Product Change Notification: PCN-23-190781

zSFP plus stack type cage assembly

ZSFP+ Stack lower spring change

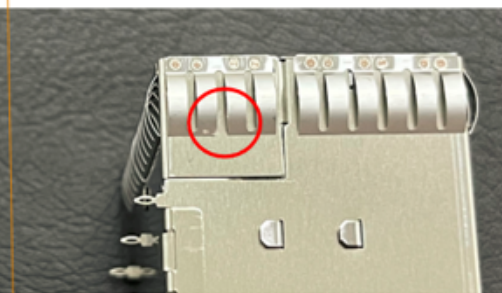
Please be aware of an upcoming feature change to the listed part numbers. Details difference see attachment. Before: Low EMI spring is whole one-piece type; After: Low EMI spring will be cut into two fingers type. This minor change does not impact EMI performance and C-drawings.

EMI spring tooling was streamlined to unify EMI spring.
